Status: Y⊠ N□ U□
Seismic Walkdown Checklist (SWC)	
Equipment ID No. <u>2R43-C006C</u> Equip. Class ¹ <u>12</u>	
Equipment Description DG 2C AIR COMPRESSOR	
Location: Bldg. DIESEL Floor El. 130 Room, Area DIESEL GEN	I ROOM 2C
Manufacturer, Model, Etc. (optional but recommended)	
Instructions for Completing Checklist	
This checklist may be used to document the results of the Seismic Walkdown of SWEL. The space below each of the following questions may be used to record t findings. Additional space is provided at the end of this checklist for documenting the space is provided at the end of this checklist for documenting the space is provided at the end of this checklist for documenting the space is provided at the end of this checklist for documenting the space is provided at the end of this checklist for documenting the space is provided at the end of this checklist for documenting the space is provided at the end of this checklist for documenting the space is provided at the end of this checklist for documenting the space is provided at the end of this checklist for documenting the space is provided at the end of this checklist for documenting the space is provided at the end of thi

3: Flex Conduit Bearing on Angle (2R43-C006C)

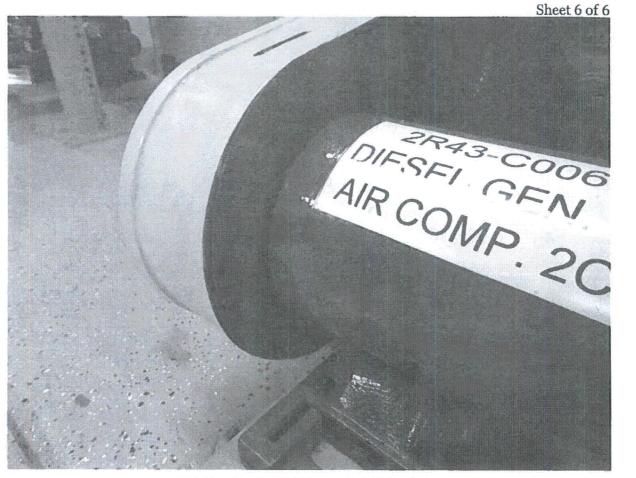
9. Do attached lines have adequate flexibility to avoid damage? The flex conduit attached to the equipment as shown in photograph 3 is in contact with the sharp edge of a supporting angle. This condition is not considered adverse in a seismic event, due to the relative small duration of vibration. Long term fretting on the conduit may occur during operation when high frequency vibrations are constantly present.	Y⊠ N□ U□ N/A□
 CR 515119 was created to address this condition. 10. Based on the above seismic interaction evaluations, is equipment free of potentially adverse seismic interaction effects? 	Y⊠ N□ U□
Other Adverse Conditions

3: Missing Grout Condition (2R43-C005C)

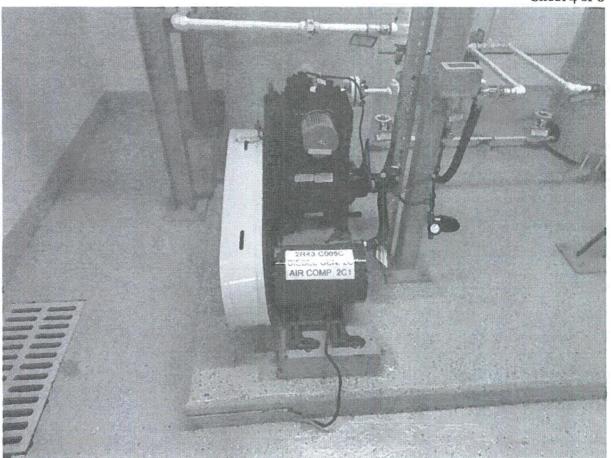
3. Is the anchorage free of corrosion that is more than mild surface oxidation?	Y⊠ N□ U□ Ñ/A□
4. Is the anchorage free of visible cracks in the concrete near the anchors? A potential seismic condition was observed. Grout is missing from under the southeast anchor of the component pad (see photograph 3). CR 515115 was written to address this condition.	Y□ N⊠ U□ N/A□

6. Based on the above anchorage evaluations, is the anchorage free of potentially adverse seismic conditions? See response to question 4.	Y□ N⊠ U□

4: Flex Conduit on Sharp Angle (2R43-C005C)

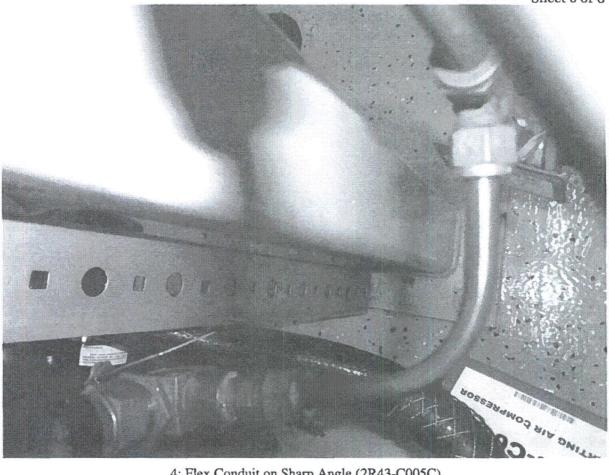
9. Do attached lines have adequate flexibility to avoid damage? The flex conduit attached to the equipment as shown in photograph 3 is in contact with the sharp edge of a supporting angle. This condition is not considered adverse in a seismic event, due to the relative small duration of vibration. Long term fretting on the conduit may occur during operation when high frequency vibrations are constantly present. CR 515118 was created to address this condition.	Y⊠ N□ U□ N/A□

Figure 3 - Light Fixture Above Motor Generator (2C71-S001A)

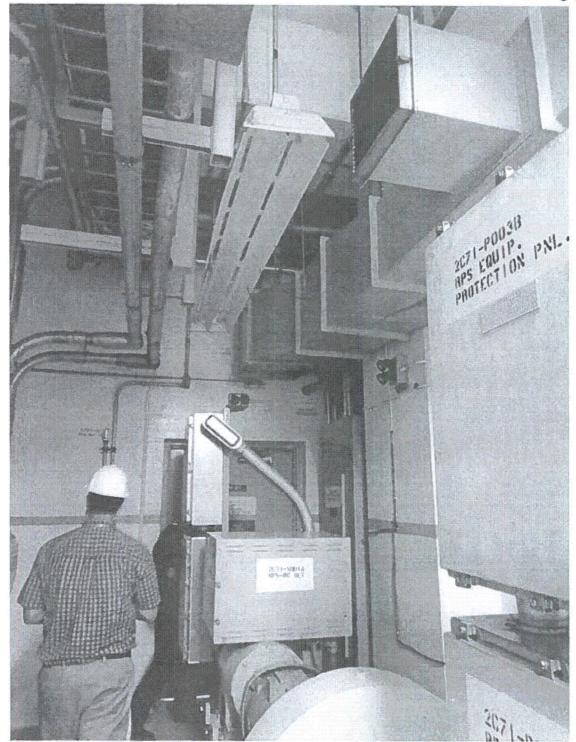
7. Are soft targets free from impact by nearby equipment or structures?	Y⊠ N□ U□ N/A□
8. Are overhead equipment, distribution systems, ceiling tiles and lighting, and masonry block walls not likely to collapse onto the equipment? The seismic capacity of the Concrete Block Walls C130-47E, C-139-54A, C130-51B, and C130-52A surrounding the component has been verified via drawing H-40383, Rev. 2 and Hatch Unit 2, UFSAR Table 3.8-20.	Y⊠ N□ U□ N/A□
There is a fluorescent light fixture without a cover located over the component. The light is tied to the ceiling, so during a seismic event, only the bulb could fall. The motor generator is very rugged and is judged to have sufficient strength as to make a possible impact between the motor generator and the bulb will be insignificant. Therefore, it is judged to be seismically adequate by the SWE's.

Figure 3 – Flourescent Light over Equipment (2C71-S001B)

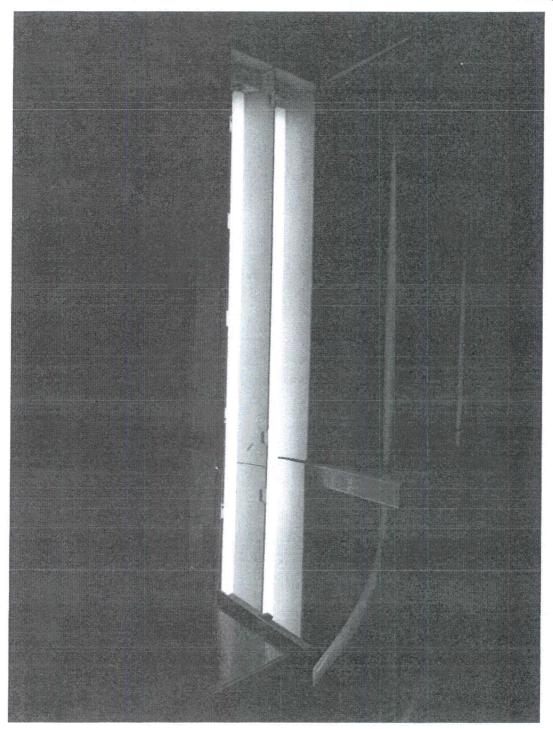
7. Are soft targets free from impact by nearby equipment or structures?	Y⊠ N□ U□ N/A□
8. Are overhead equipment, distribution systems, ceiling tiles and lighting, and masonry block walls not likely to collapse onto the equipment? The seismic capacity of the Concrete Block Walls C130-47E, C130-50B, C130-51A and C130-54A surrounding the Motor Generator were verified using Drawing H-40383 Rev. 2 and Hatch Unit 2 UFSAR	Y⊠ N□ U□ N/A□
Table 3.8-20. There is a fluorescent light fixture without a cover located over the component. The light is tied to the ceiling, so during a seismic event, only the bulb could fall. The motor generator is very rugged and is judged to have sufficient strength as to make a possible impact between the motor generator and the bulb insignificant. Therefore, it is judged to be seismically adequate.

Figure 4 – Drilled Holes in Motor Casing (2C71-S001B)

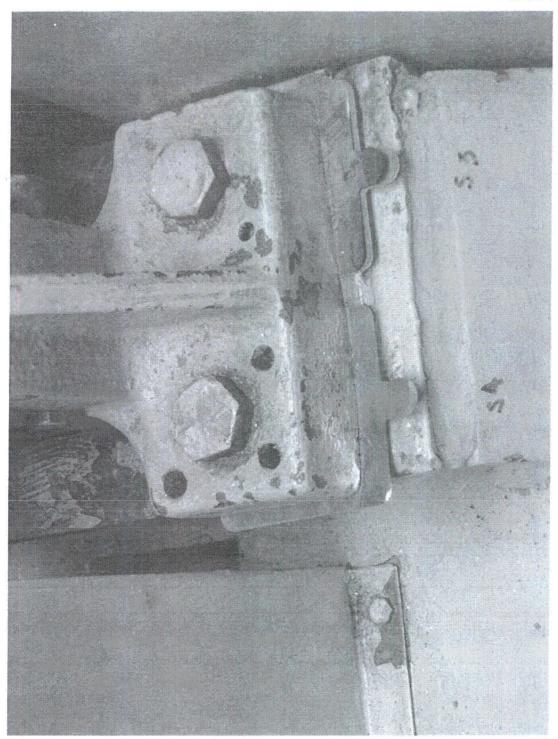
11. Have you looked for and found no other seismic conditions that could adversely affect the safety functions of the equipment? There are a number of drilled holes in the casing of the motor, particularly at anchorage locations. These holes appear to have been drilled to alter the balance of the motor and are clearly unrelated to component anchorage. Their presence does not indicate missing anchors or screws. Therefore, there is no potentially adverse seismic condition.	YM NO UO
Comments (Additional pages may be added as necessary)	
See Component 1C71-S001B for the Area Walk-by Checklist.	
Evaluated by: John McFarland Horton	Date: <u>09/17/2012</u>

Figure 4 - Mild Acid Residue on Bolts (2R42-S001A)

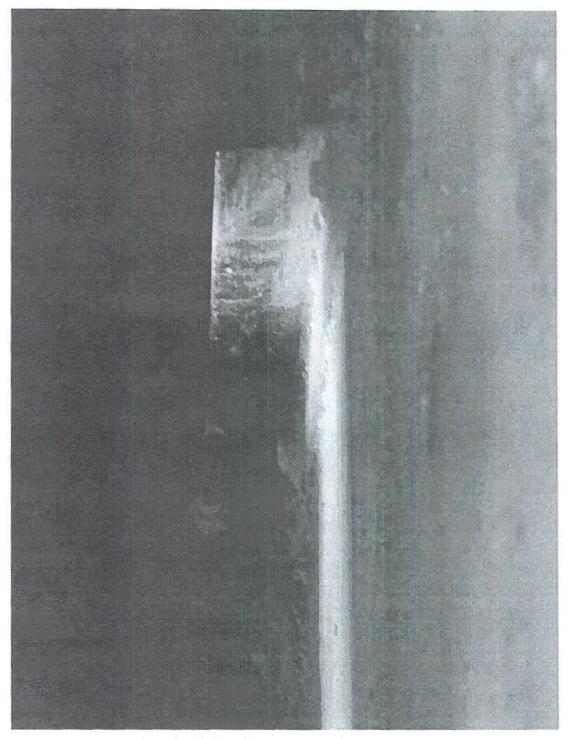
3. Is the anchorage free of corrosion that is more than mild surface oxidation?	Y⊠ N□ U□ N/A□				
There is some acid residue on the bolts from the batteries, but the paint has prevented any significant corrosion of the bolts. Since the corrosion is only on the surface, there is no potentially adverse seismic condition.
